# ENGINEERING ORDER

1. ENGINEERING ORDER NO. 2010C0651

| 2. DWG TITLE | 3. DWG CAGE CODE | 4. DWG NO. |
|---|---|---|
| Selector, Cabin Temperature (NOT AVAILABLE IN JEDMICS) | 97896 | P8-1A |

| 5. NEXT ASSY | 6. USED ON | 7. OPR CAGE CODE | DWG SIZE | DWG SHEET(S) | LATEST DWG REV LTR |
|---|---|---|---|---|---|
| | C/KC-135 Aircraft | 98748 | | | |

5. DESCRIPTION OF CHANGES/REMARKS

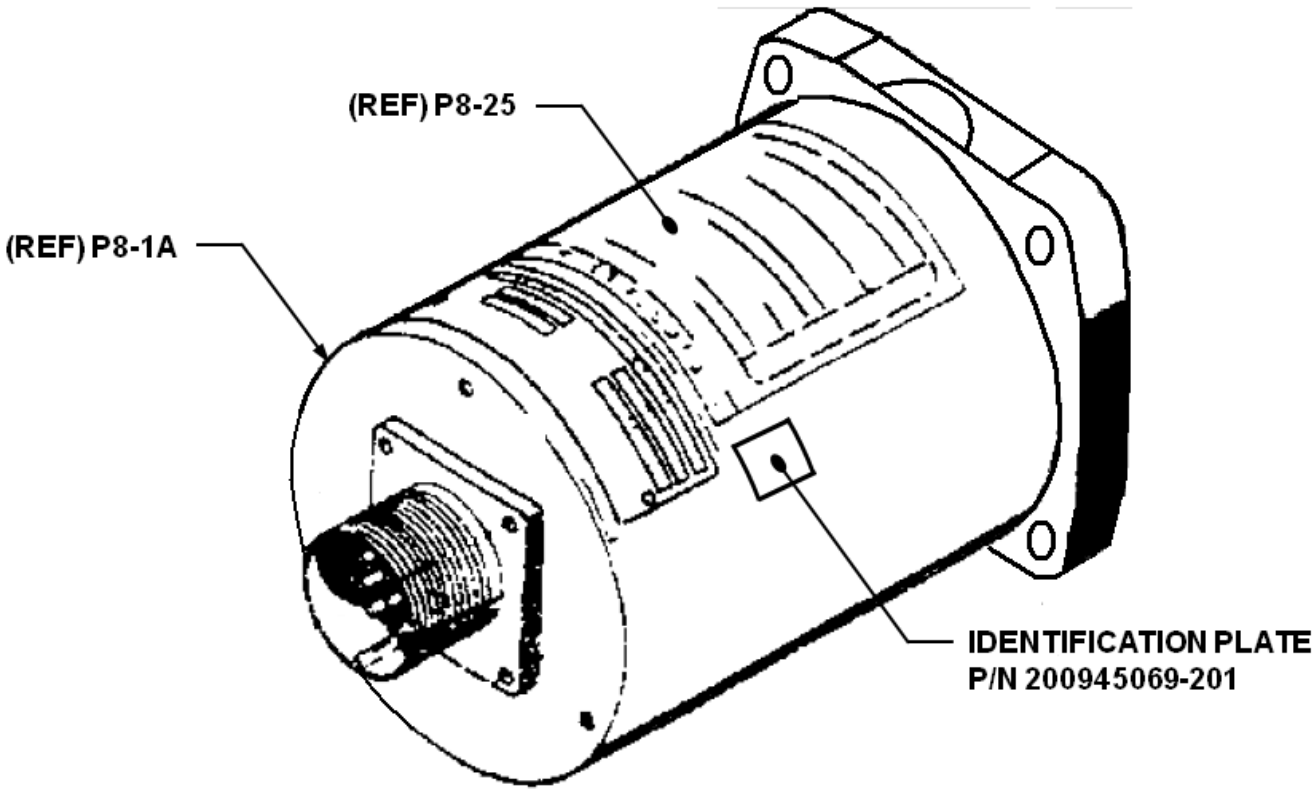
- C/KC-135 Aircraft Cabin Temperature Selector, (PN P8-1A) shall be marked with a Unique Item Identifier (UII). (REF: MIL-STD-130)

- If no UII symbol is present, fabricate new identification plate (200945069-201) and add to end item.

- New UID identification plate will be located adjacent to the existing label. See sketch/photo on page 2, AF form 3926.

- After attaching IUID plate to end item, apply a thin overcoat to IUID plate ensuring the plate edges are sealed, using 1A20, 1A33, or equivalent Polyurethane Conformal Coating, per manufacturer's instructions. REF: MIL-I-46058C
